## **Proposal for amendments to the 04 series of amendments to UN Regulation No.41 (Noise of L3 category of vehicles)**

The text reproduced below was prepared by the expert from the International Motorcycle Manufacturers Association (IMMA) to amend UN Regulation No. 41-04 (up to Supplement 7), in order to clarify the implications of footnote one on the requirements specified in Annex 4. The modifications to Regulation No. 41 are marked in bold for new or strikethrough for deleted characters.

Figure 1

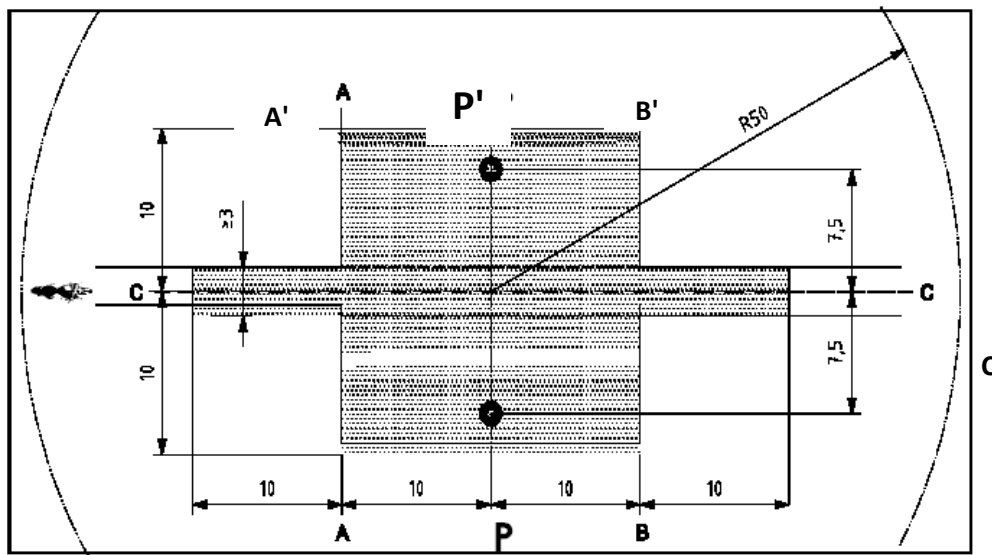
Remark: ISO10844:2014 does not include an equivalent to Annex 4, Figure 1 or a description of the test area which includes the microphone position(s) and the width of the driving lane.

Figure 2

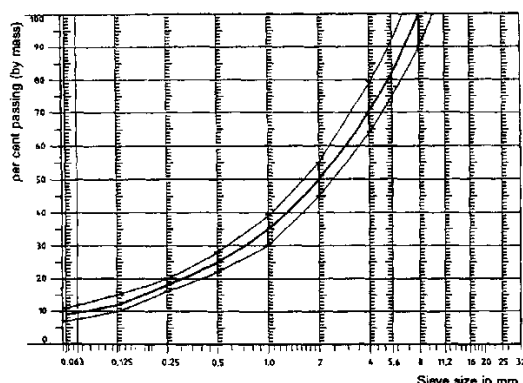
Remark: ISO10844:2014 does not include equivalent elements to Annex 4, 3.2.2. in its' normative section, but only in its' informative section. The substitution of elements of Annex 4 by means of informative elements of an ISO standards is inappropriate.
